RE: Draft Discharge Permit, DP-1840, Copper Flat Mine

NMED has imposed additional conditions on DP-1840 that are not requirements of the Copper Mine Rule (20.6.7 NMAC). Pursuant to Subsection I of 20.6.7.10 NMAC, NMED is providing the following written explanations of the reasons for the additional conditions.

Figure 1 – Authorized Mine Unit Footprints

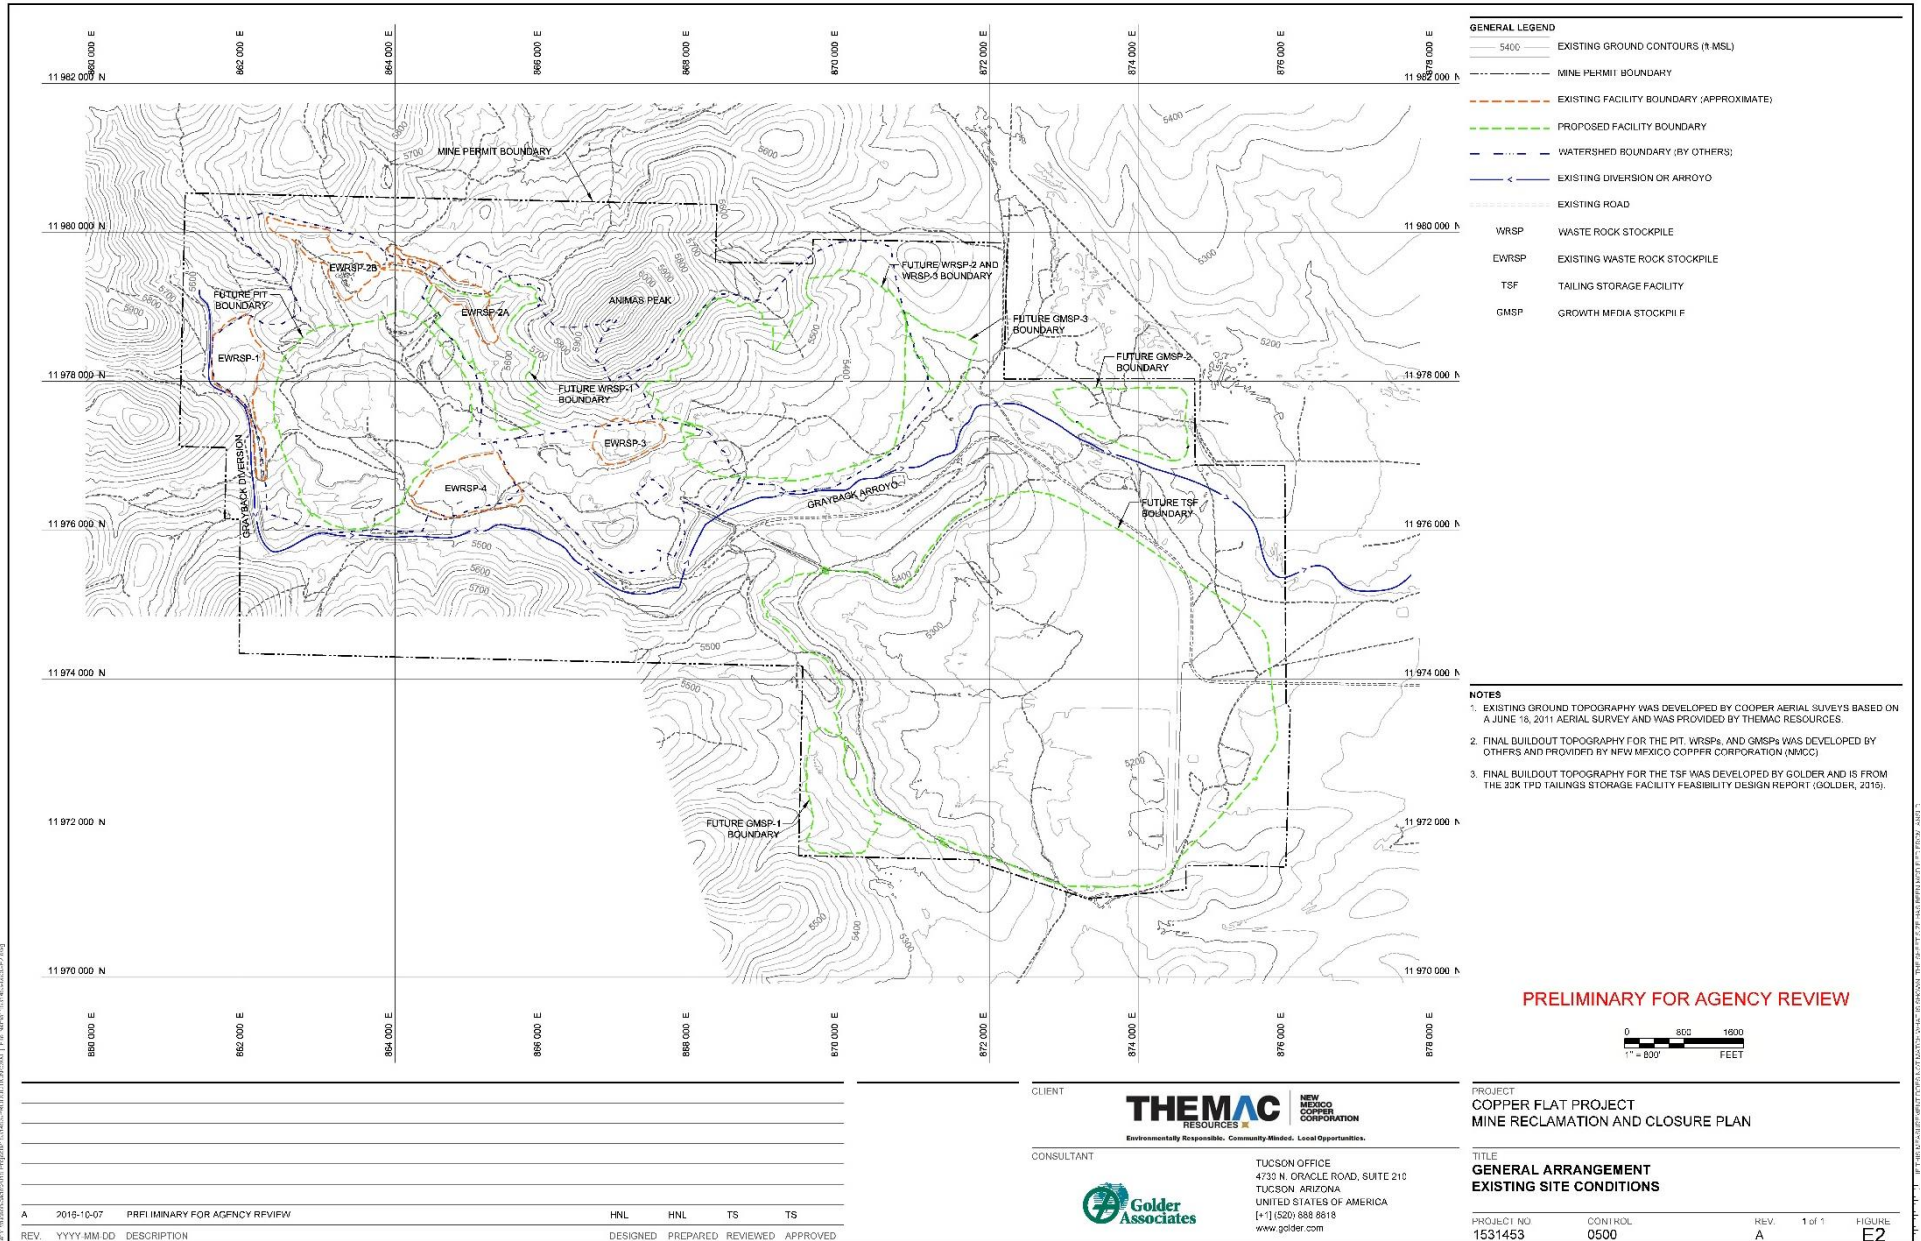
Figure 1 – NMCC suggests that Figure E3 from the MORP, Appendix E, General Arrangement at Final Build-out should be utilized as a better representation of the authorized mine unit footprints.

Figure 1: Map showing the Ladder Ranch, north of the dark property line, and the general location of the Copper Flat Mine.

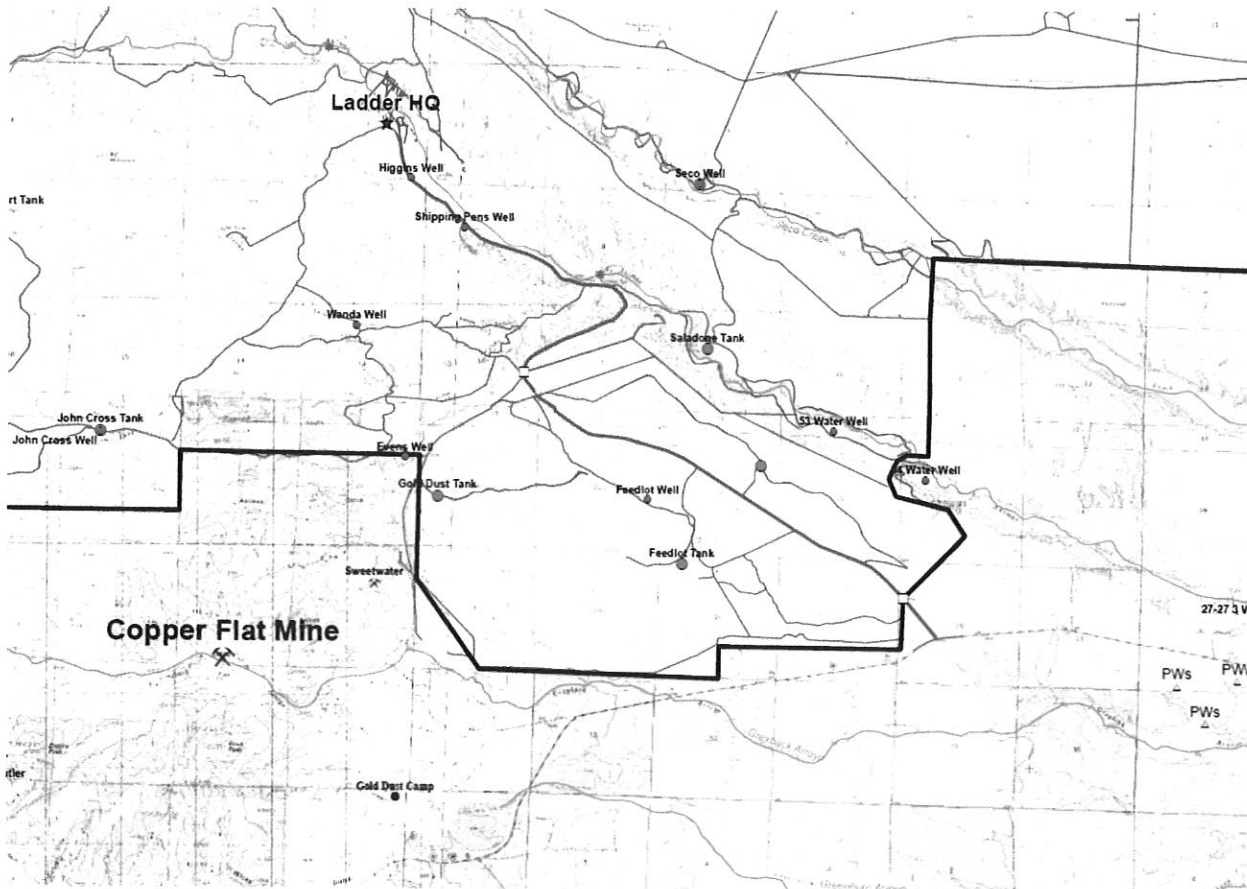
Ladder Ranch lies east and north of the proposed Mine, as shown in Figure 1. As will be discussed below in the memorandum, the groundwater flows west to east through the Mine site and onto the Ranch. Contaminant plumes would disperse laterally, so most contaminants released from the Mine would flow through or under the Ladder Ranch. Upon my review, the Draft Permit violates the Copper Rule on the Ranch in the following ways:

The Ranch lies east and north of the proposed Mine, as shown in Figure 1. Groundwater flows west to east through the Mine site, and a contaminant leak from the TSF would disperse laterally - possibly resulting in contaminants reaching groundwater underneath the Ranch property. Additionally, wells and springs on the Ranch could become contaminated by discharges that exceed water quality standards set forth in Section 20.6.2.3103 NMAC. This potential contamination poses both a hazard to

Figure 2: Figure 6.6 from Jones et al (2014).

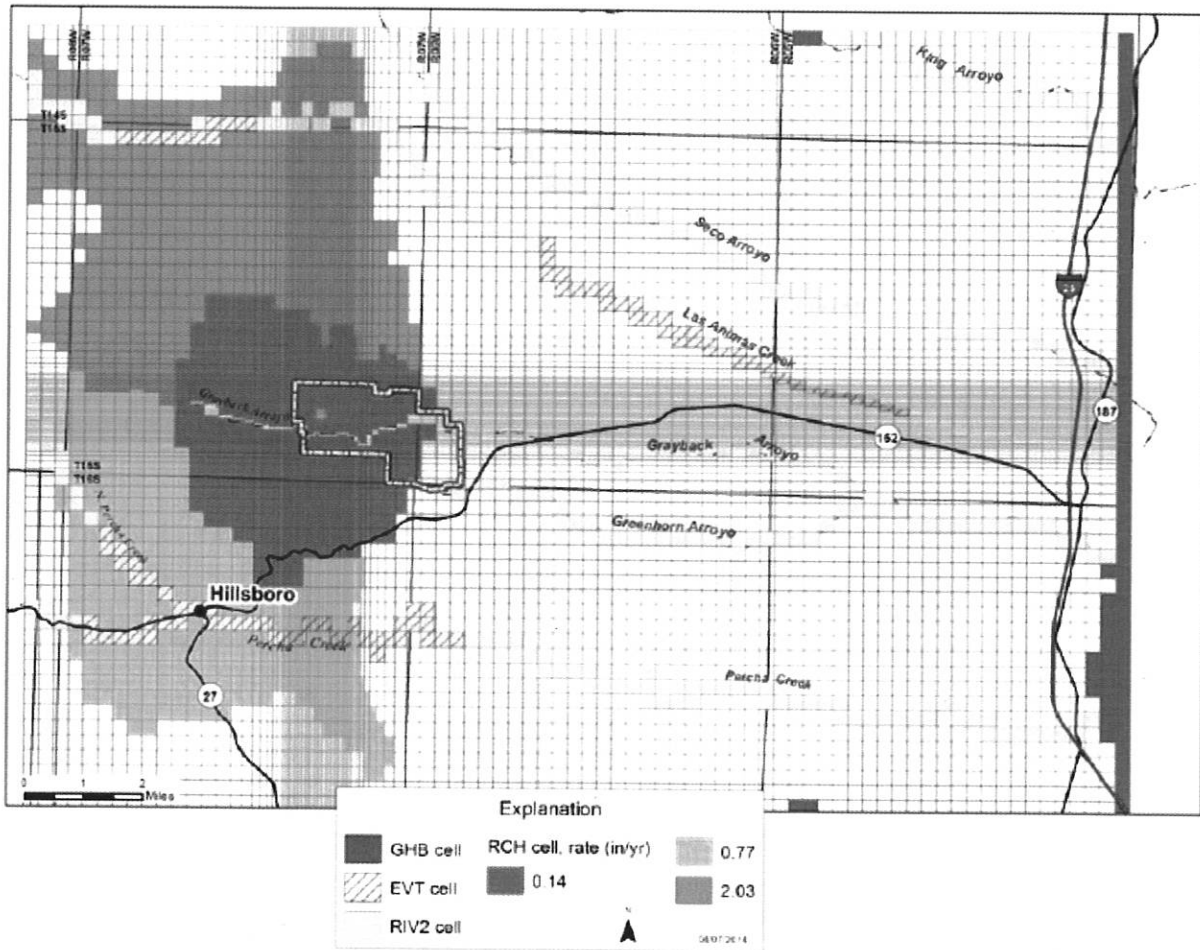
The groundwater model steady state calibration (Jones et al 2014, section 6.3) balances recharge with discharge to surrounding streams. The pinkish area in Figure 2 is the andesite and has recharge equal to 0.14 in/y; the area east of that is the Natomas basin which has no recharge. The rate corroborates the rate estimated above for offsetting the dewatering and evaporation rates. Because groundwater discharges other than to the pit lake, such as to springs, streams, and the Rio Grande downgradient from the Mine area, the calibrated recharge rate is clearly too low.

Figure 3.1. Projected end-of-mining groundwater drawdown in the SFG aquifer.

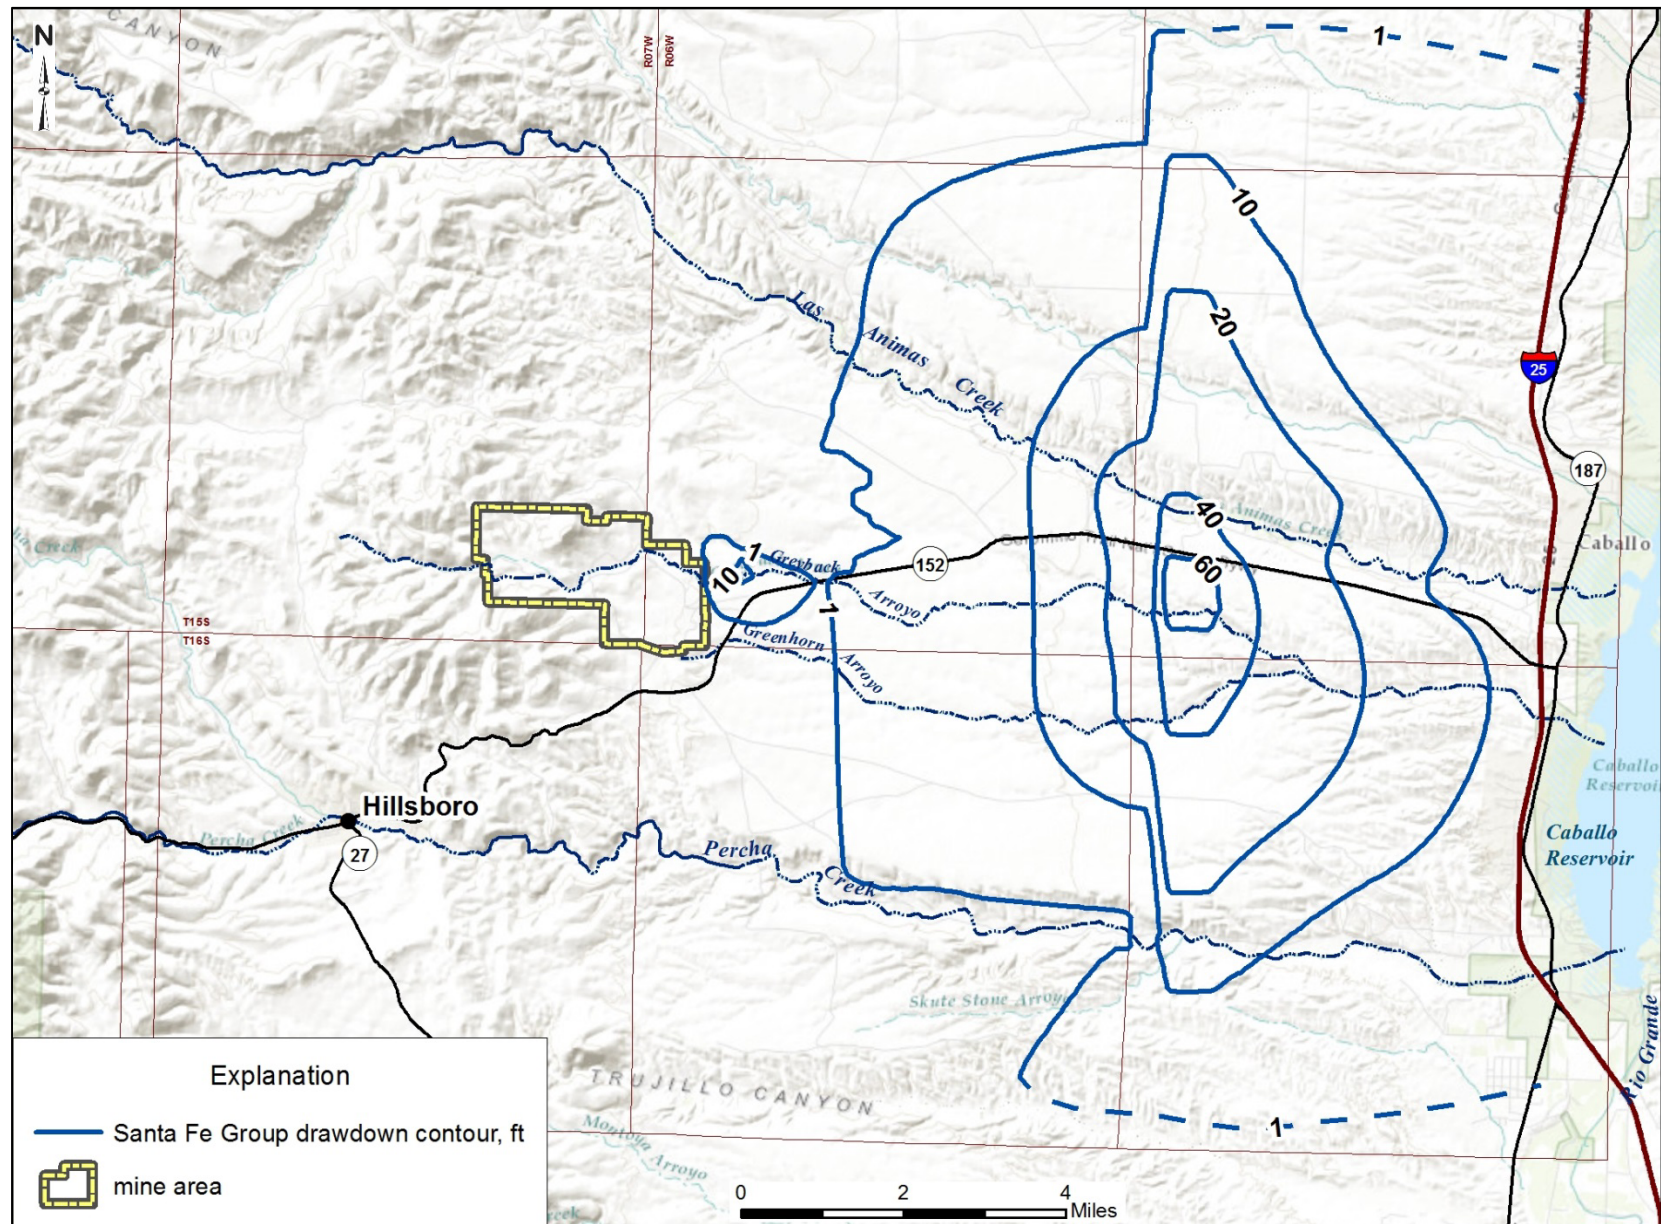
3. Figure 3.1: The 1 foot contour in this figure shows an abrupt turn to the east on the north side of Percha Creek. This figure is similar to Figure 3-19b in the Draft Environmental Impact Statement ("DEIS"; November 2015), which appears to show that this portion of the contour is controlled by negligible predicted drawdown in well LRG-10948, as shown in Figure A14 of the JSAI Report. However, LRG-10948 is listed in the Baseline Data Report ("BDR"; June 2012 by Intera) as a Percha Creek alluvial well (see Section 8.2.4.3.3 of the BDR) whereas Figure 3.1 represents projected groundwater drawdown in the Santa Fe Group ("SFG") aquifer. If LRG-10948 is an alluvial creek well, the predicted 1 foot contour would likely continue in the SFG south across Percha Creek. Please comment on whether LRG-10948 is modeled as an alluvial creek well or as a SFG well and any changes this may make on the predicted drawdown within the SFG at the end-of-mining.

3. Figure 3.1: The 1 foot contour in this figure shows an abrupt turn to the east on the north side of Percha Creek. This figure is similar to Figure 3-19b in the Draft Environmental Impact Statement ("DEIS"; November 2015), which appears to show that this portion of the contour is controlled by negligible predicted drawdown in well LRG-10948, as shown in Figure A14 of the JSAI Report. However, LRG-10948 is listed in the Baseline Data Report ("BDR"; June 2012 by Intera) as a Percha Creek alluvial well (see Section 8.2.4.3.3 of the BDR) whereas Figure 3.1 represents projected groundwater drawdown in the Santa Fe Group ("SFG") aquifer. If LRG-10948 is an alluvial creek well, the predicted 1 foot contour would likely continue in the SFG south across Percha Creek. Please comment on whether LRG-10948 is modeled as an alluvial creek well or as a SFG well and any changes this may make on the predicted drawdown within the SFG at the end-of-mining.

Figure 3.12. Projected end-of-mining groundwater drawdown in the crystalline bedrock.

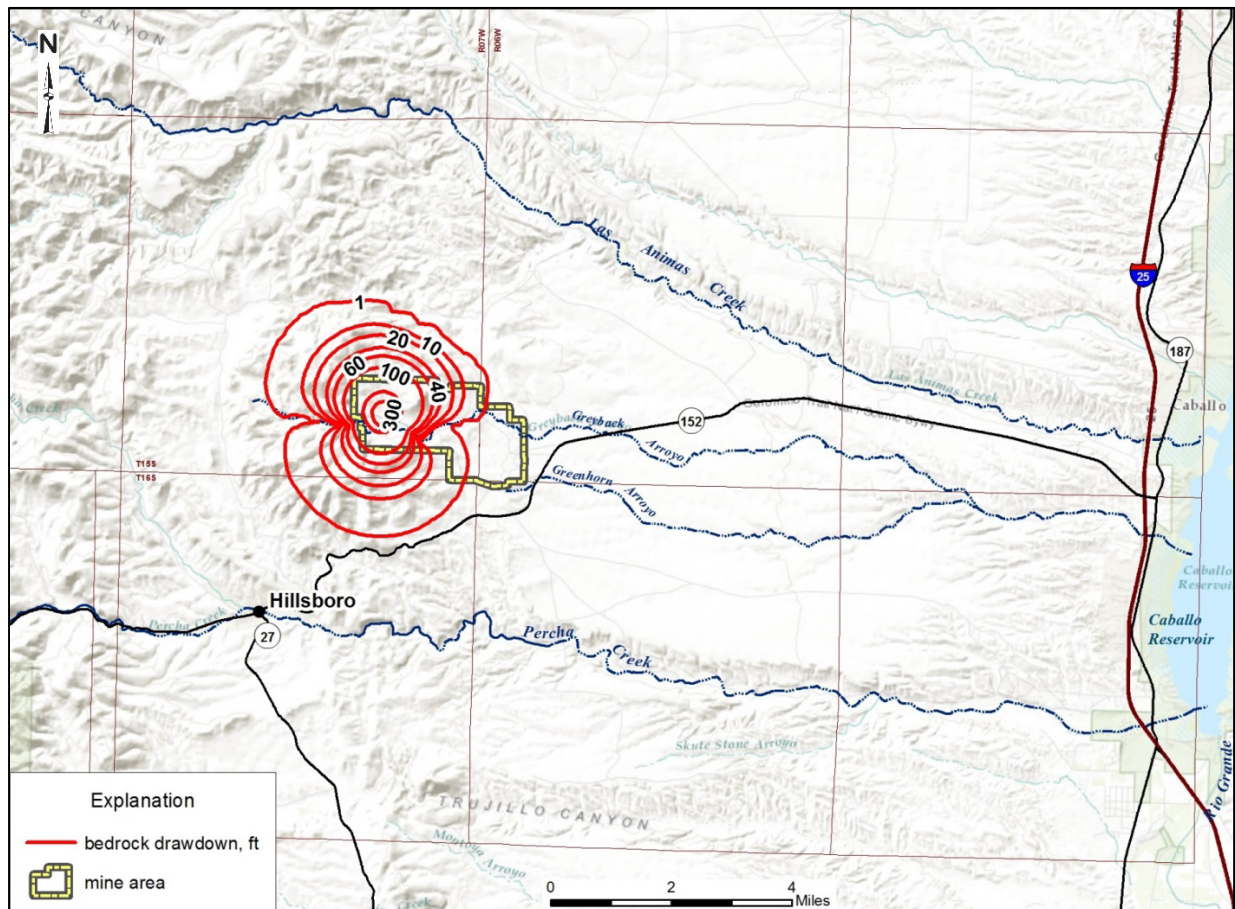
4. The drawdown contour intervals of Figure 3.12 versus Figure A1 are different. Please include an approximate 1 foot drawdown contour on Figure A1 to allow for comparison of the end-of-mining drawdown versus the anticipated effects 100-years after mining.

4. The drawdown contour intervals of Figure 3.12 versus Figure A1 are different. Please include an approximate 1 foot drawdown contour on Figure A1 to allow for comparison of the end-of-mining drawdown versus the anticipated effects 100-years after mining.

Figure 3.16. West-to-east hydrogeologic cross-section E-E' showing water-level profile across existing pit and proposed open pit after rapid fill.

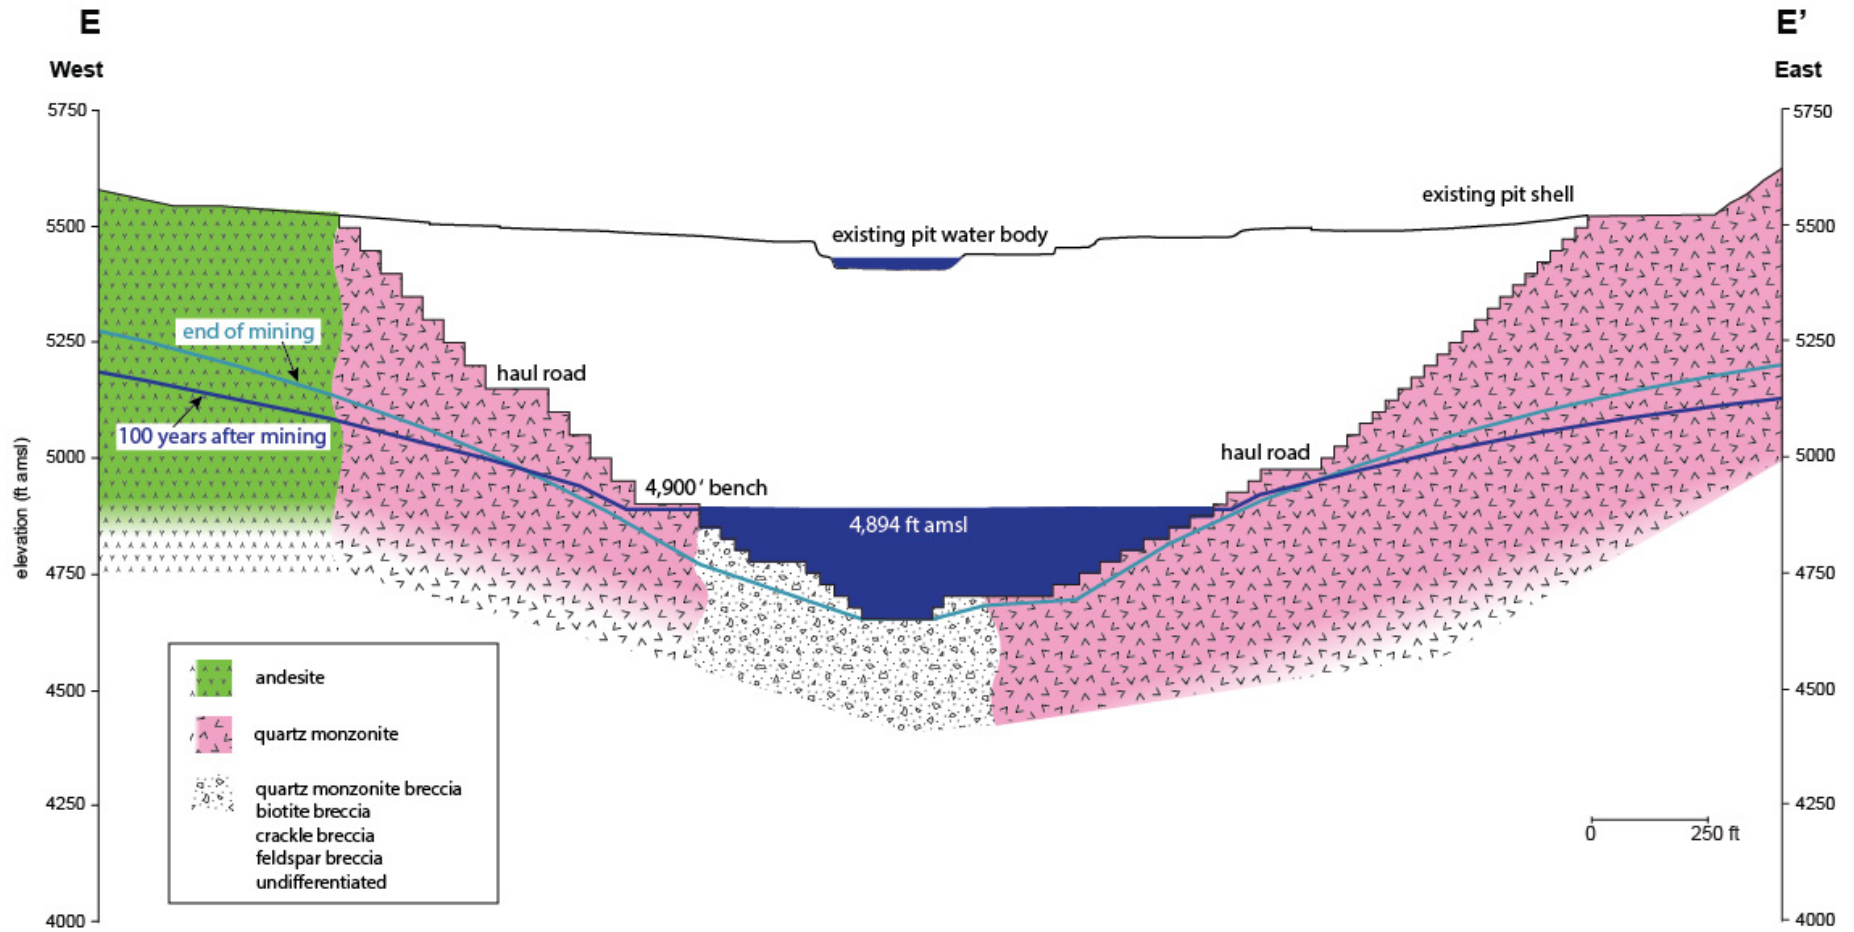
The first reason the simulated water table is inaccurate is that the calibrated andesite K is two orders of magnitude less than the measured values. Therefore, the water table drawdown forms a steep cone near the pit, as shown in NMCC's modeled results in Figure 3. If the K was higher, as measured, there

The third reason the simulated water table is inaccurate is the drawdown cone generated by dewatering in a formation with higher K would be much more spread out, and flatter, than the one shown in Figure 3. Drawdown caused by dewatering in a sloped groundwater table, west to east as occurs pre-mining at the Mine, forms a groundwater divide²² east of the pit. This “capture zone” defines an area from which water will be drawn to the pit, or pit lake. The elevation of the groundwater divide depends on the K of the formation in which it is calculated, the recharge entering the formation near the pit, and the steepness of the original water surface through the pit. The groundwater divide in a more conductive pit formation would occur further downgradient from the pit and therefore would be lower because the pre-mining water table would be lower. The groundwater divide would also be lower if the pre-mining groundwater table was steeper. Higher recharge would increase the water flowing to the pit and needing to be dewatered, so for a given K it would raise the groundwater divide because a higher gradient would be required to cause the water to flow toward the pit.
